## Aquifer Test Technical Review

From: John Seaberg, PG, Groundwater Specialist

Subject: 2020-2578, Riverview Dairy, Twelvemile

**Figure 3. Groundwater Use and Groundwater Levels at Dollymount Dairy**

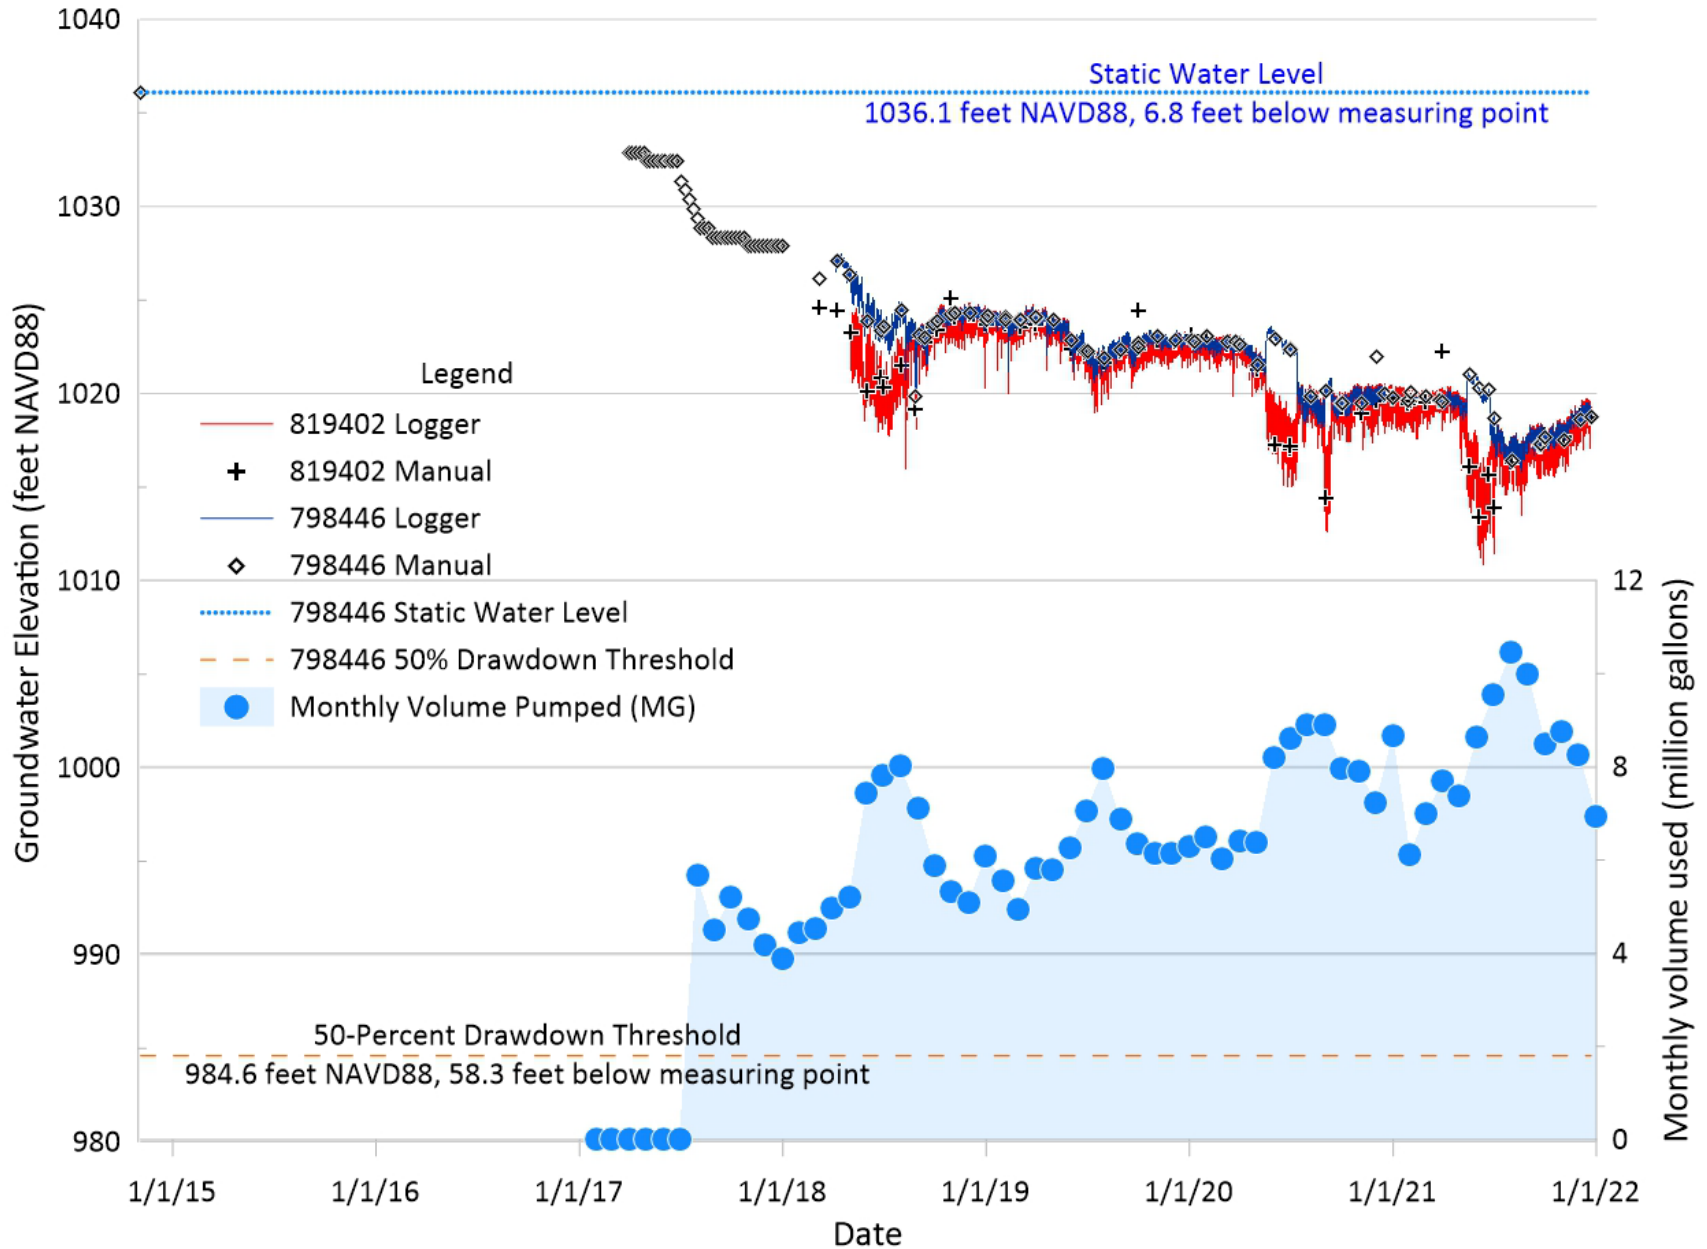
Riverview LLP has been monitoring groundwater levels at its nearby Dollymount Dairy (Figure 1) in two dedicated monitoring wells to comply with permit conditions. Although one well (798446) is screened at an elevation approximately 50 feet higher than the other well (819402), both are interpreted to be screened in the same aquifer owing to the similar hydraulic responses to pumping. The hydrographs presented for these wells in Figure 3 represent the historical water level record for each. Additionally, this graph illustrates groundwater use associated with the Dollymount Dairy, which began operation during the summer of 2017. This figure readily shows that the water levels in each of the wells respond to variations in pumping, as evidenced by sudden decreases in water level in response to increased water use. Moreover, the hydrographs show a clear downward trend in the water levels as pumping has increased over that same period. The decreasing water levels have not yet shown any signs of stabilizing. Although the water levels have decreased a minimum of 20 feet, they still remain approximately 30 feet higher than the 50-percent drawdown threshold for that aquifer.

Figure 4. Water Level Displacement for All Wells Monitored during Aquifer Test

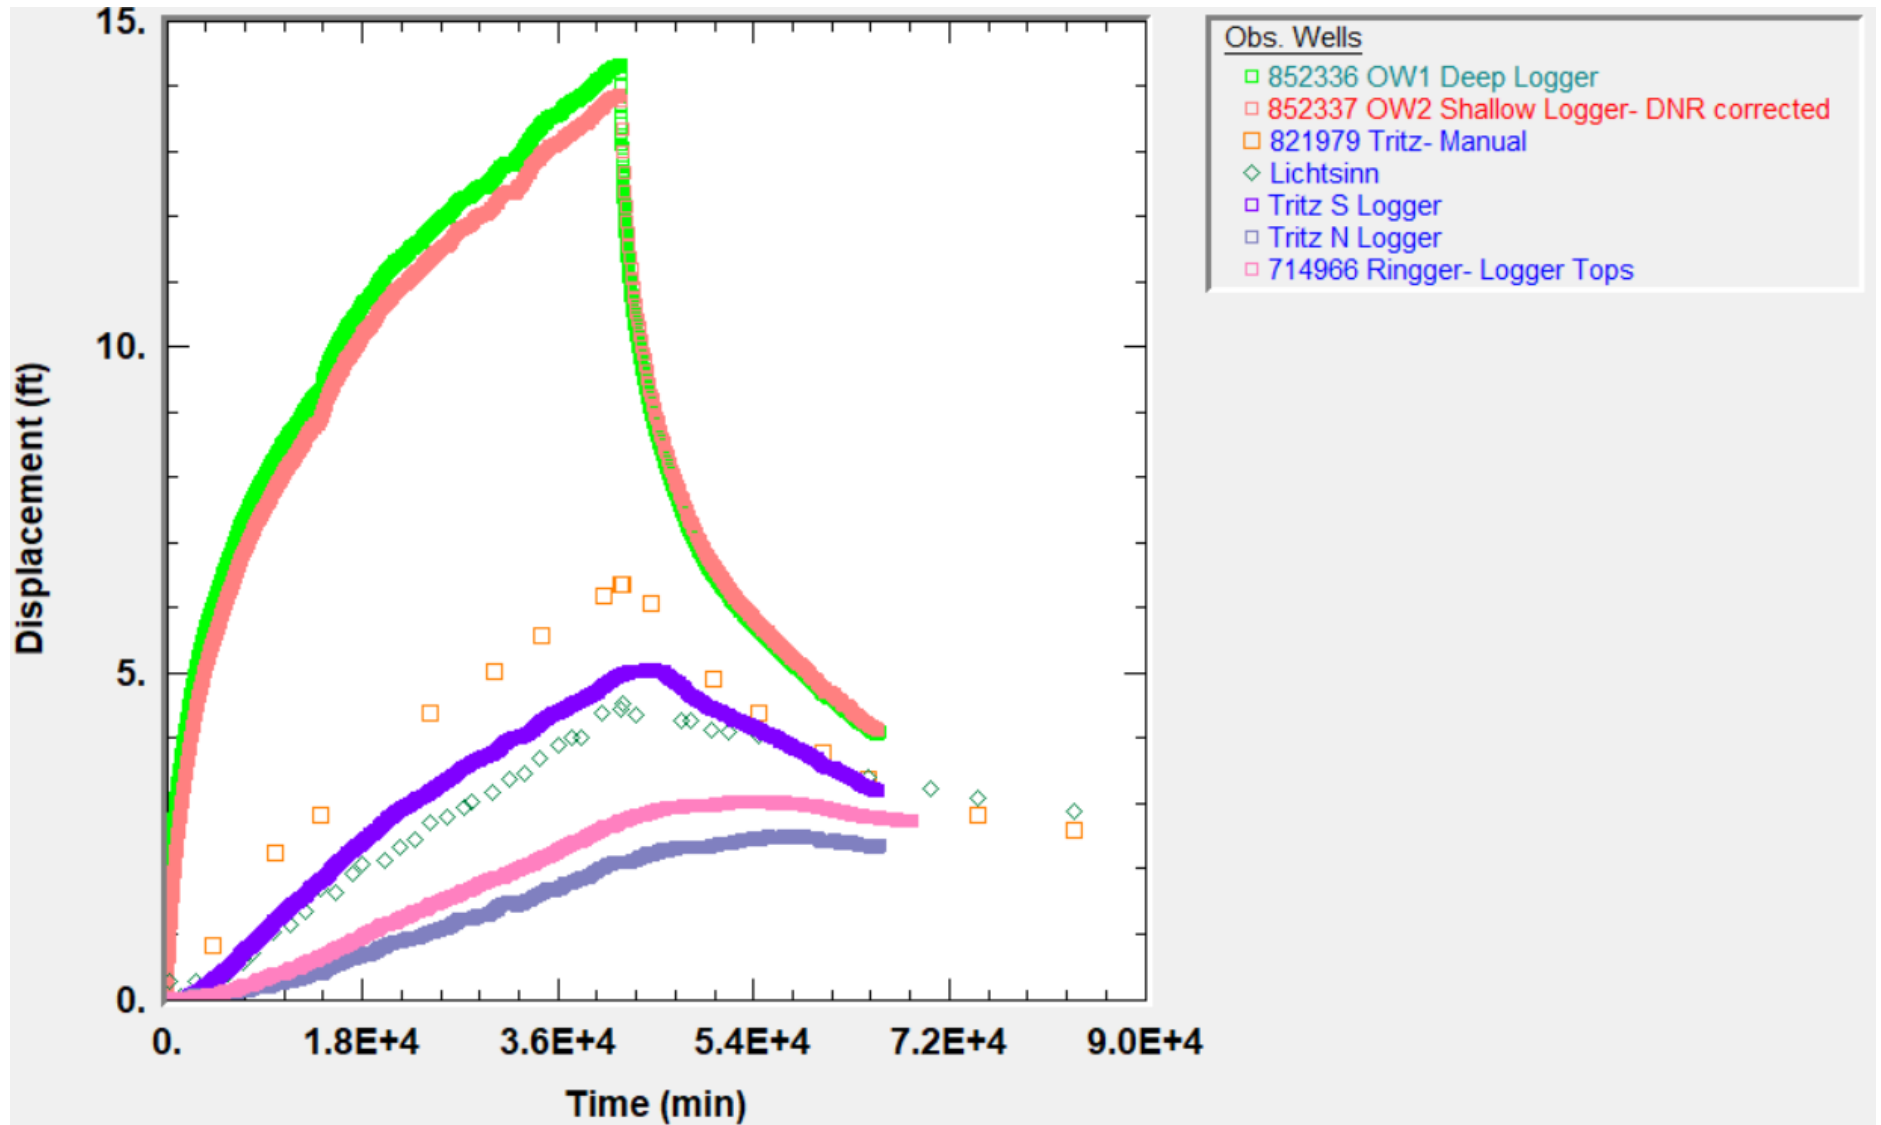
and during the pumping and recovery phases of the test in the pumped Well PW-1, Observation Wells OW-1 and OW-2, and five private domestic wells (Tritz Ab North, 821979 Tritz, Tritz Ab South, 714966 Ringger, and Lichtsinn) (locations shown in Figure 2). Drawdown in response to pumping PW-1 was observed in all seven observation (non-pumped) wells, as shown on Figure 4, which shows displacement during the pumping and recovery phases of the test. The Consultant used results from Wells PW-1, OW-1, OW-2, Tritz Ab North, Tritz Ab South, and Lichtsinn, and applied several analytical methods and various boundary scenarios to determine hydraulic parameters using the aquifer hydraulics analysis software AQTESOLV (Duffield, 2007). They concluded that the transmissivity ranged from 600 to 5600 feet<sup>2</sup>/day with a geometric mean of 2200 feet<sup>2</sup>/day, while acknowledging that the complex glacial geology could be problematic in developing a model that provides a consistent match for the data from all the wells. They estimated storativity values to range from 0.00029 to 0.022, attributing the higher values to wells completed in the QBAA. Values of hydraulic conductivity were estimated for each well based on the results and aquifer thickness at each location, and yielded a geometric mean value of 22 feet/day.

As previously noted, there is also strong lateral hydraulic connection between the pumped deep aquifer and private domestic wells located up to 1.6 miles away from Production Well PW-1, as evidenced by the drawdown response seen during pumping (Figure 4). Water level recovery was evaluated as a qualitative indicator of how readily the hydrogeologic system is recharged. Table 5 summarizes the maximum recovery that was initially measured in each of the wells as part of the aquifer test, including Production Well PW-1.

Figure 5. Drawdown Displacement and Derivatives for OW-1 and OW-2

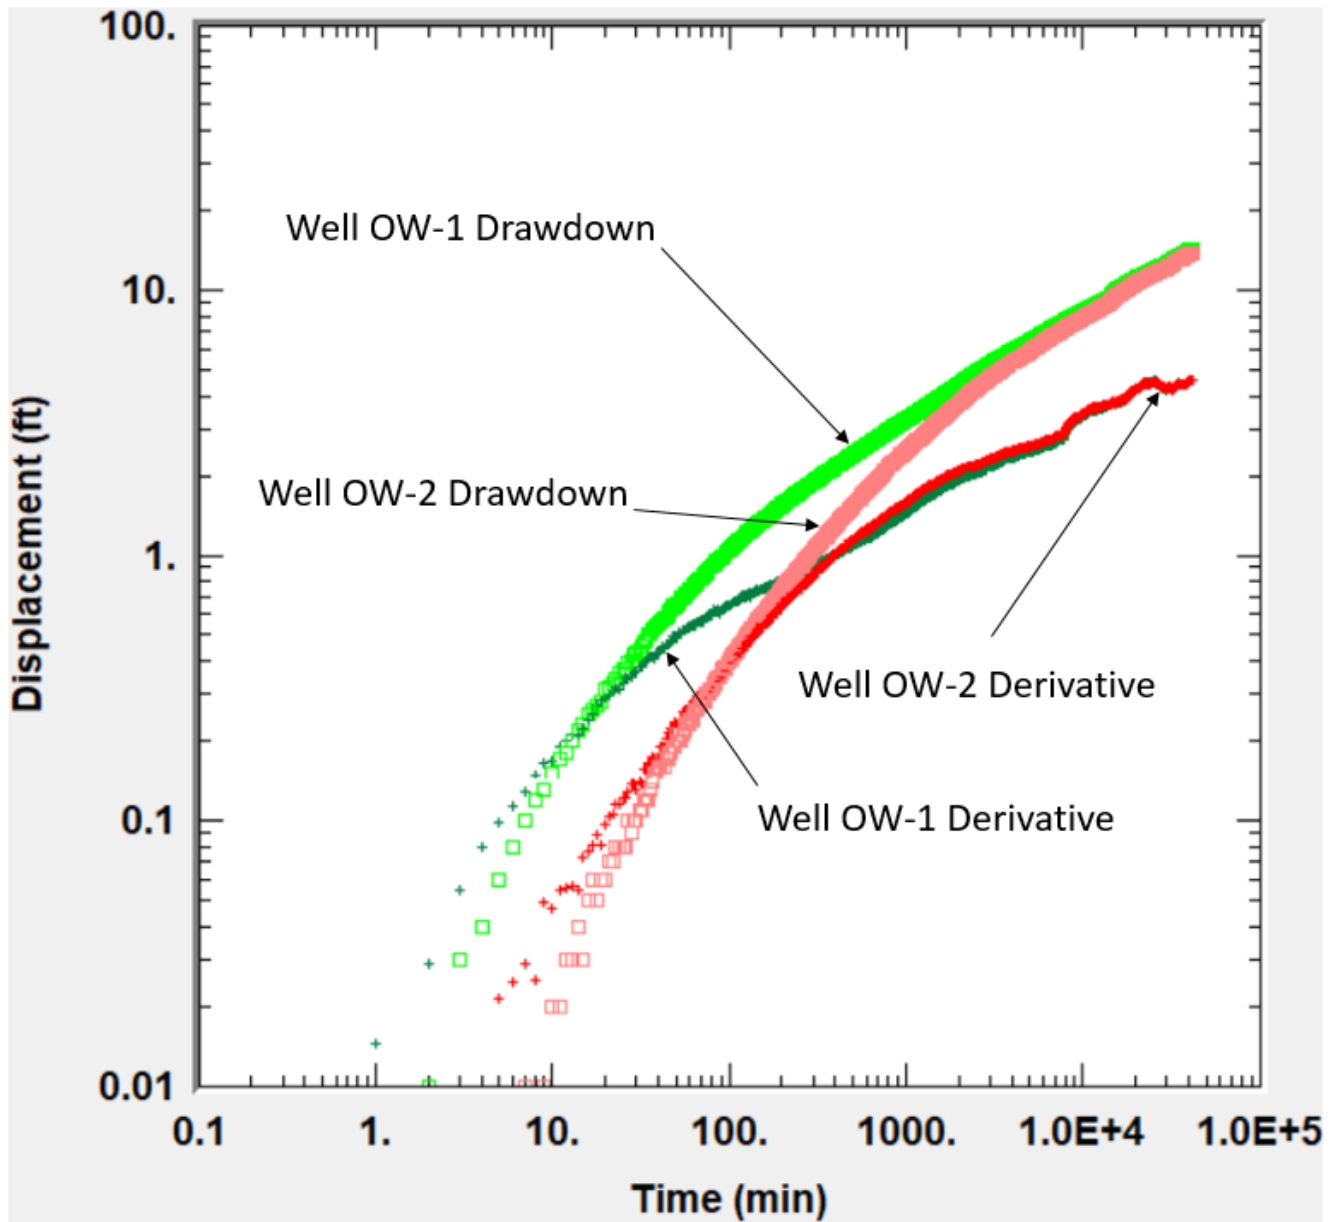
Figure 5 shows the drawdown in Wells OW-1 and OW-2 during the pumping phase of the aquifer test, as well as the derivative for each curve. The derivative for the drawdown curve of Well OW-1 is characteristic of that for a permeable channel aquifer embedded in a lower permeability matrix (Butler and Liu, 1991). This is consistent with the conceptual model that we developed based on the geology and drawdown response observed in the private domestic wells. Consequently, a number of potential no-flow boundaries were evaluated in AQTESOLV to approximate this model. Figure 6 illustrates the locations of four potential no-flow barriers. All were evaluated by applying them to the solution in AQTESOLV in various combinations. Ultimately, it was found that the no-flow boundary on the west side of the pumping wells (defined by Points A and D) provided the best solution fit. Although we know the hydrogeology is much more complicated than this representation, it provided the best empirical fit to the drawdown data for both wells.

Figure 7. Aquifer Test Results (log-log axes) Using Neuman and Witherspoon (1969)

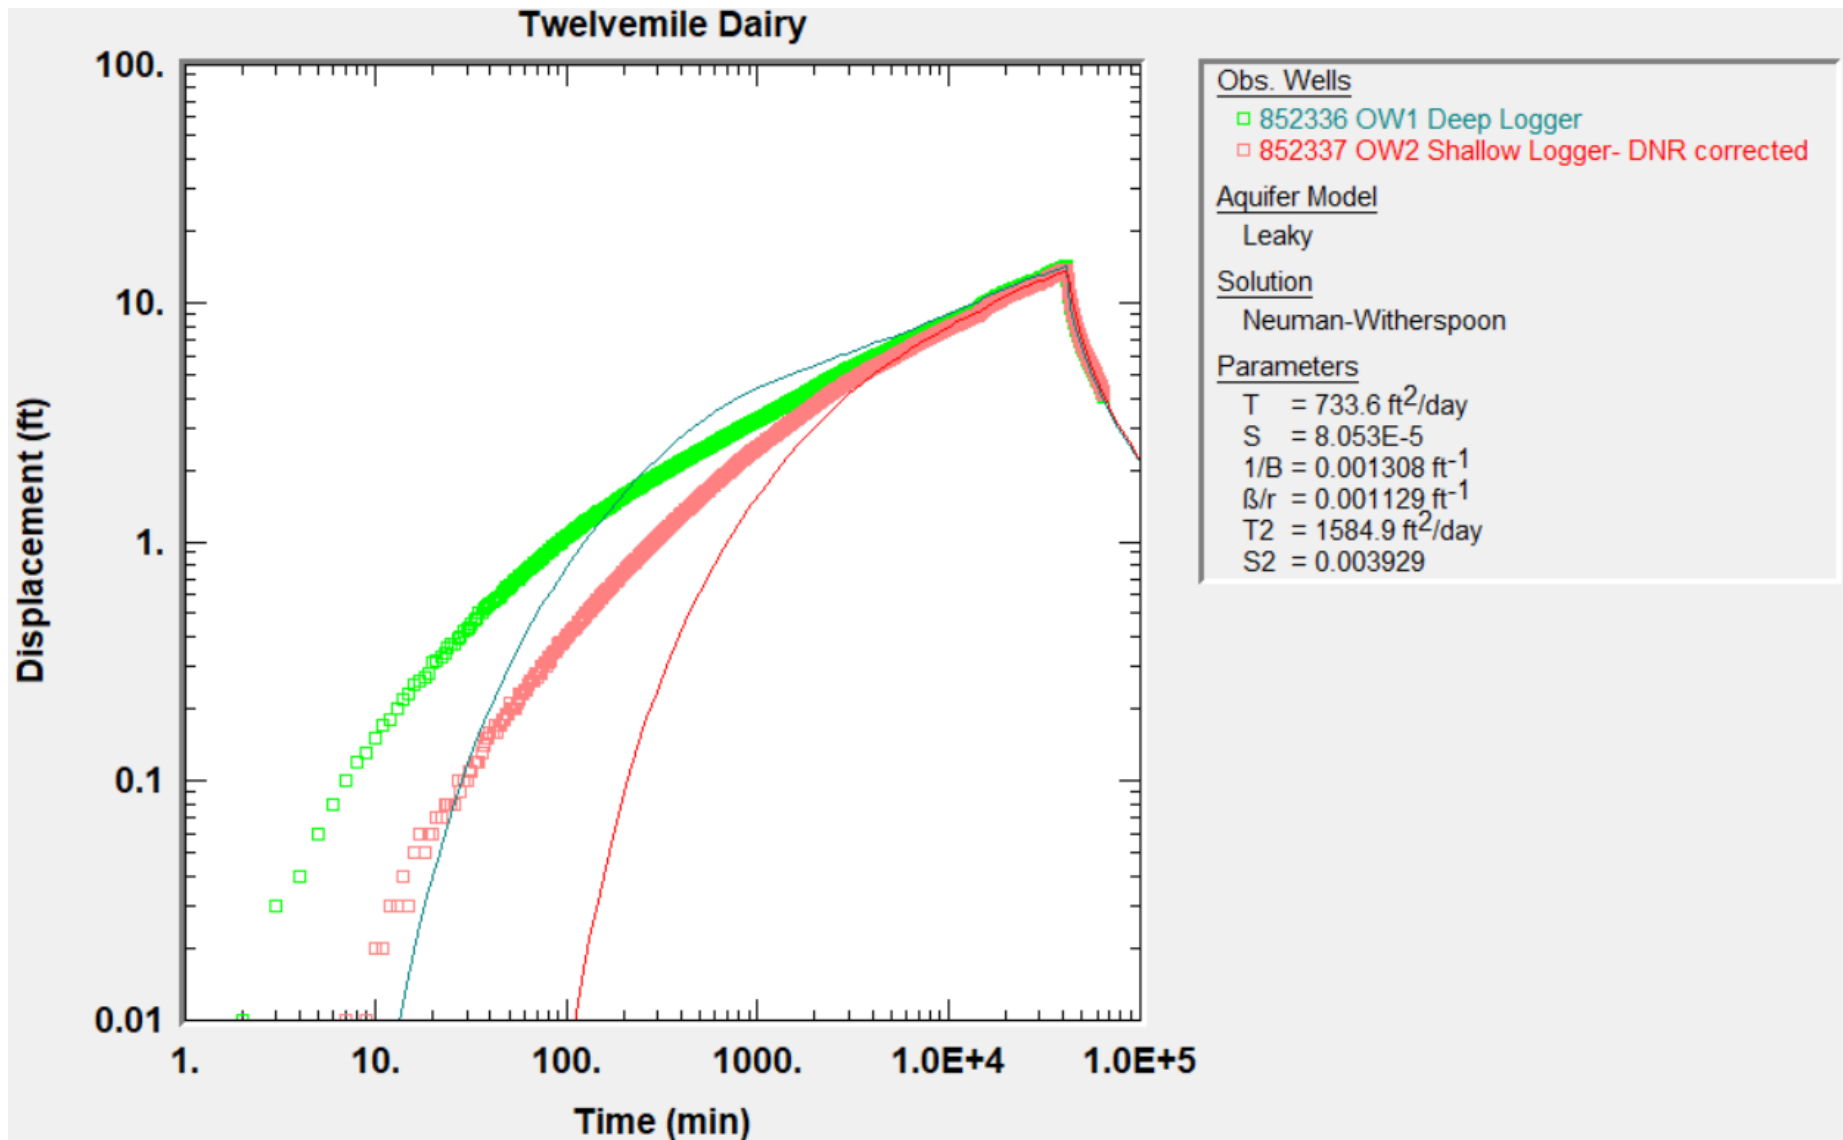
Since the analysis involves a two-aquifer system separated by an aquitard, the Neuman and Witherspoon (1969) method was used to analyze the data. Figure 7 presents both drawdown and recovery data for Wells OW-1 and OW-2, and the analytical results using the Neuman and Witherspoon (1969) method with the inclusion of the western no-flow boundary. Later drawdown data as well as recovery data appear to show a good fit to the solution curves. However, to reduce the graphical distortion that occurs from using log-log axes, the data and solutions were also plotted using linear axes, as shown in Figure 8, which shows very tight agreement between the data and analytical model. This approach yielded a transmissivity of 730 feet<sup>2</sup>/day and a storativity of 8.1E-5 for the deep aquifer has. Similarly, the shallow aquifer was estimated to have a transmissivity of 1600 feet<sup>2</sup>/day and a storativity of 0.0039. Additionally, this analysis estimates the vertical hydraulic conductivity of the aquitard that separates these two aquifers to be 0.050 feet/day. Table 4 summarizes these aquifer parameters, and also includes aquifer parameters estimated for the QBAA at the Dollymount Dairy site (Walker, 2019) and the Cretaceous aquifer parameters estimated by the Consultant (LRE Waters, 2021) for the proposed Twelvemile site to allow for ready comparison. Overall, the parameters estimated for the QBAA at the Dollymount site are consistent with those that DNR determined for the QBAA at the Twelvemile site. Similarly, LRE Water’s (2021) values for the Cretaceous aquifer at the Twelvemile site are generally consistent with DNR’s values for that aquifer, with the exception of the storativity value. The upper range determined by LRE Water (2021) likely overestimates the storativity for a confined aquifer, and DNR’s estimate appears to underestimate the value considered normal for a confined aquifer (Freeze and Cherry, 1979).
